NRCB Natural Resources
Conservation Board

Application under the *Agricultural Operation Practices Act* for a confined feeding operation, manure collection area, and/or manure storage facility(ies)

NRCB USE ONLY	Application number	Legal land description
<input type="checkbox"/> Approval <input type="checkbox"/> Registration <input checked="" type="checkbox"/> Authorization <input type="checkbox"/> Amendment	<u>LA25007</u>	<u>NW 10-11-21 W4M</u>

**Re: Geotechnical Review and Evaluation
Proposed Catch Basin
NW-10-11-21-W4, near Picture Butte, Alberta**

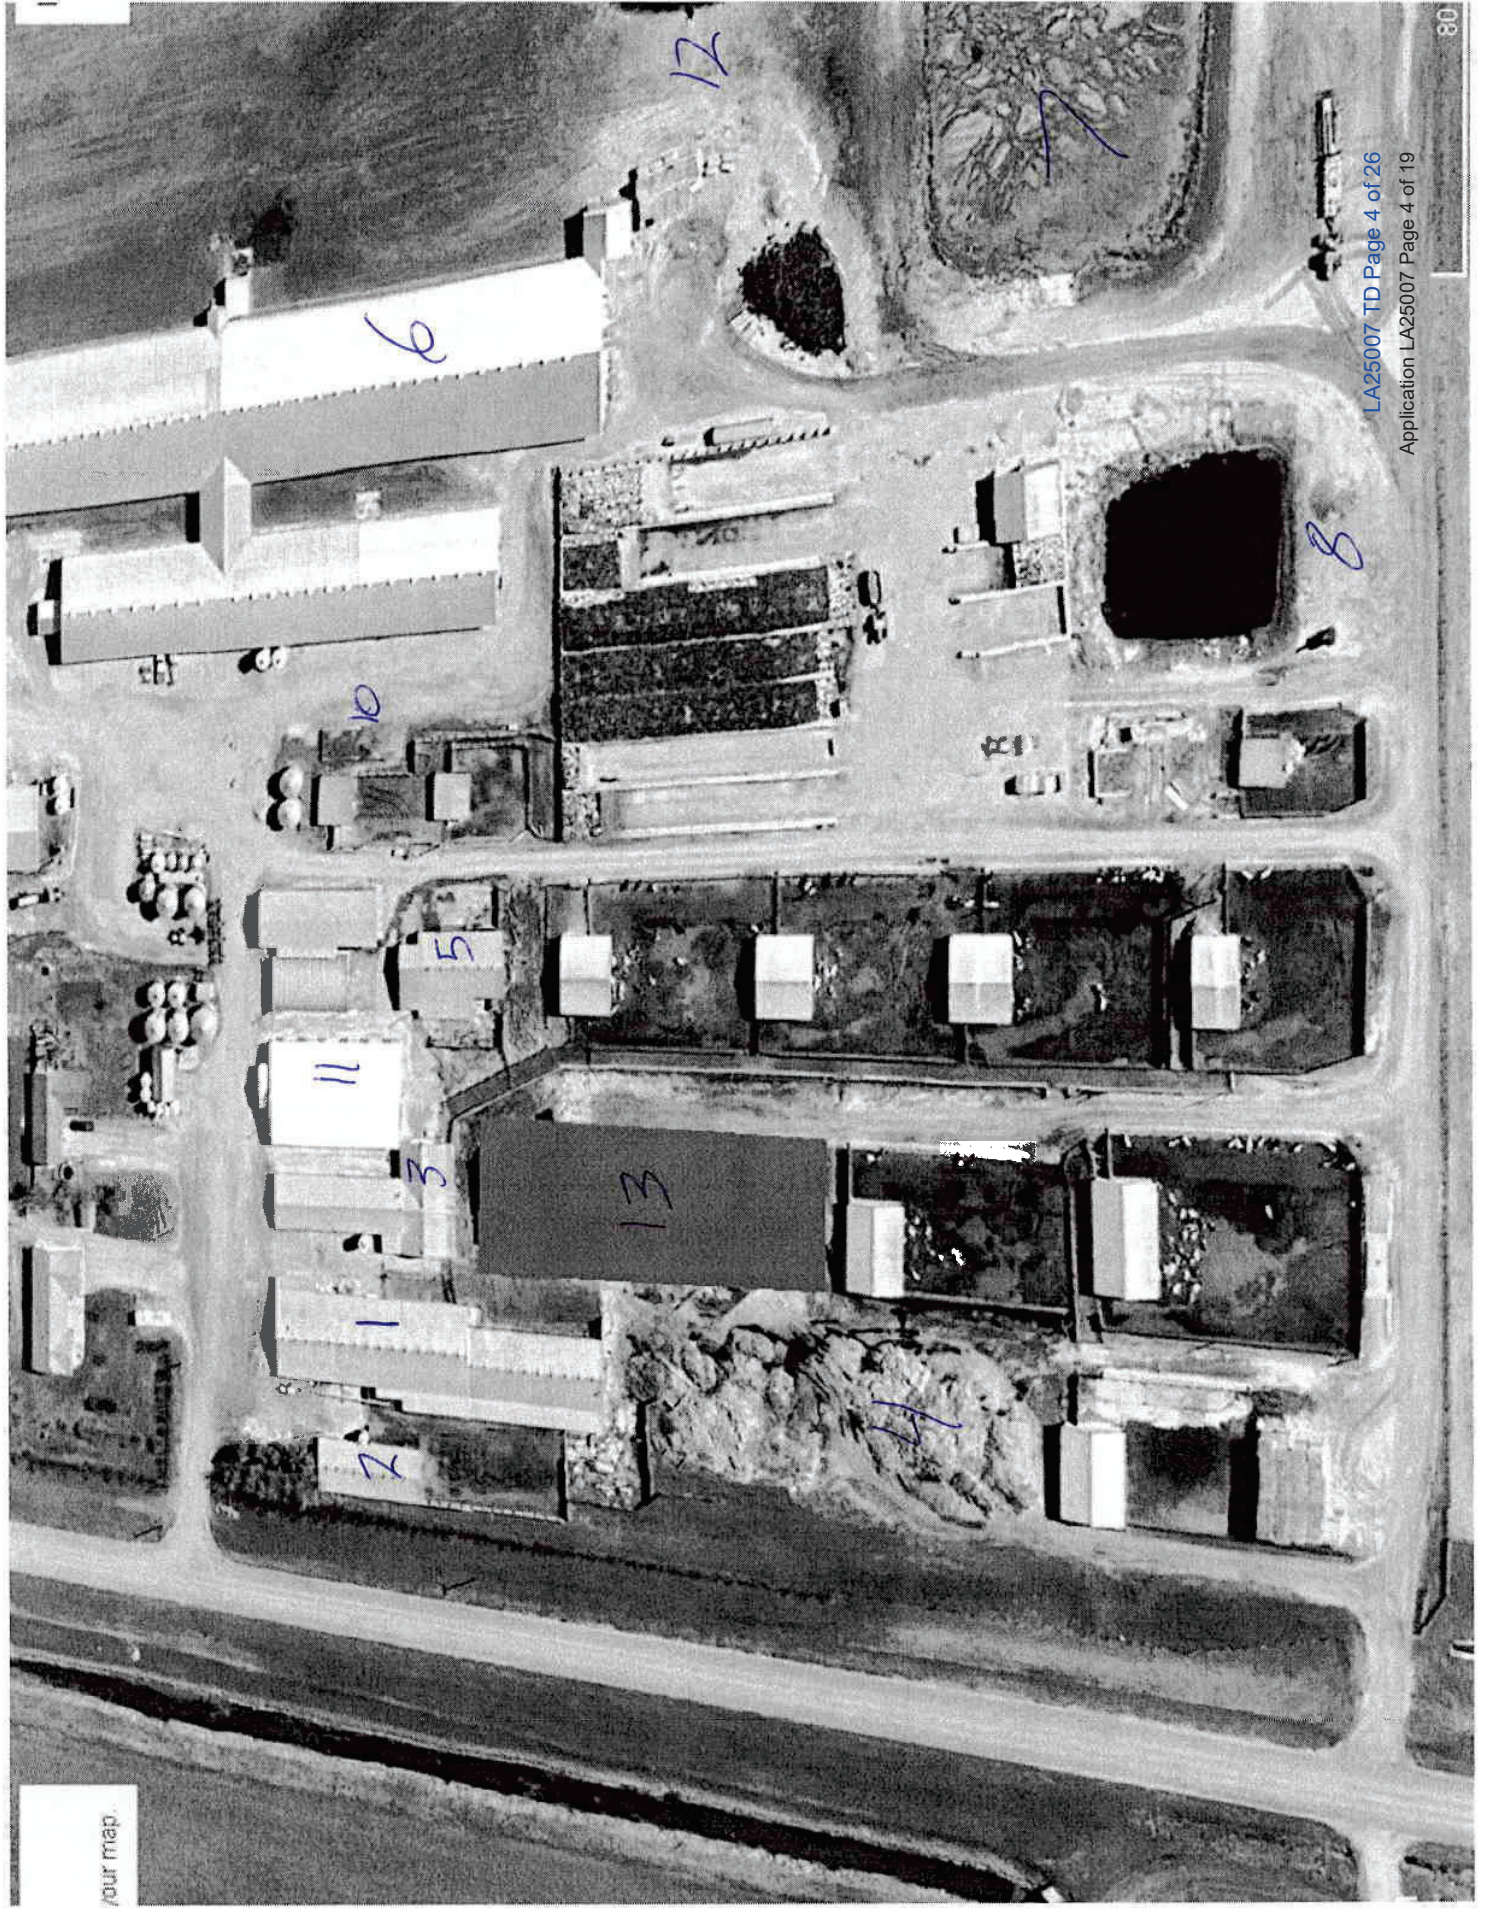
Proposed facilities	Dimensions (m) (length, width, and depth)
2 corrals	40x30x1
2 shelters with an open south side in the corrals	23x11x3.75
AO Note: The applicant is proposing 2 pens, each 40 m x 30 m. The total proposed dimensions are 80 m x 30 m. The shelters are within the footprint of the pens and are not separate facilities

AO Note, the applicant is proposing to construct shelters in these pens; therefore they will be partially covered

Figure 1 – Borehole Location Plan
In Situ Permeability Test Calculations
Borehole Logs
Explanation of Symbols and Terms used on Logs

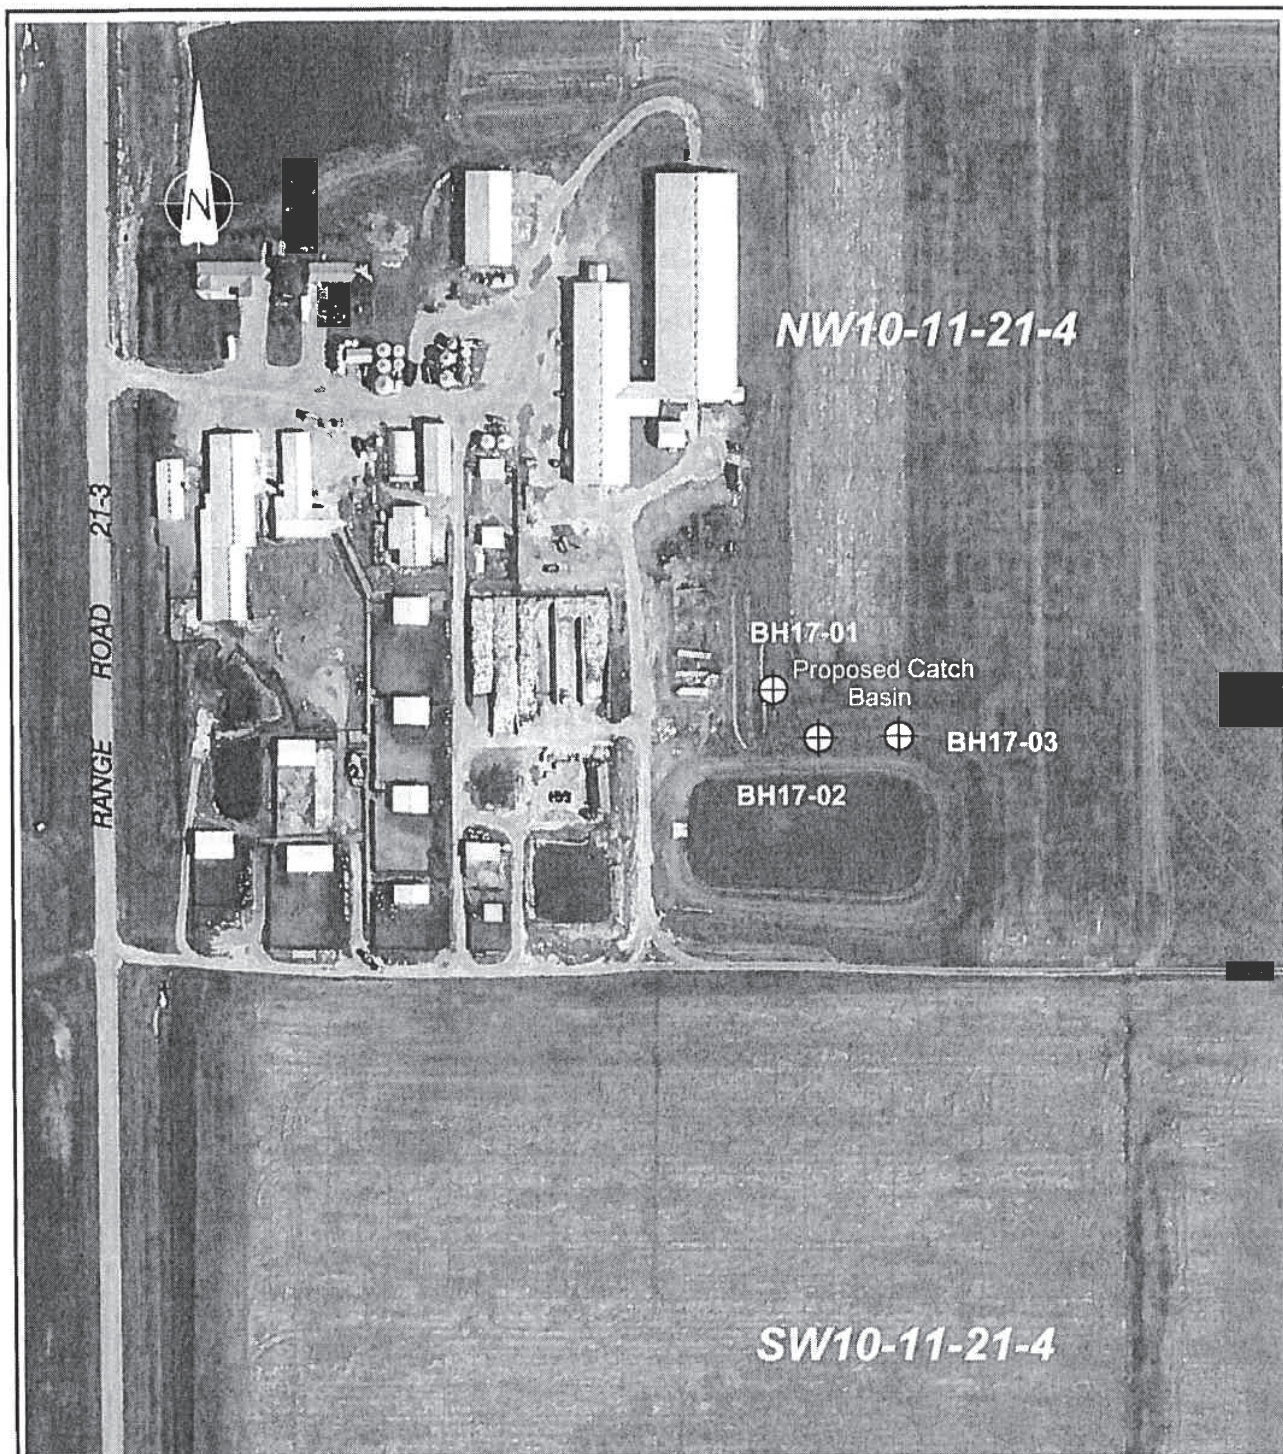
Layer specification comments (e.g. sand lenses; layering uniform or irregular; number and location of boreholes):
BH17-02, 3.1 m thick clay till from 6.9 m to 10.1 m below grade.

I used Technical Guideline Agdex 096-63 "Subsoil Investigations for Naturally Occurring Protective Layers" when assessing the soils investigation report for this application. Based on the proximity from the test holes to the proposed pens, I can extrapolate that the naturally occurring protective layer extends under the pens.
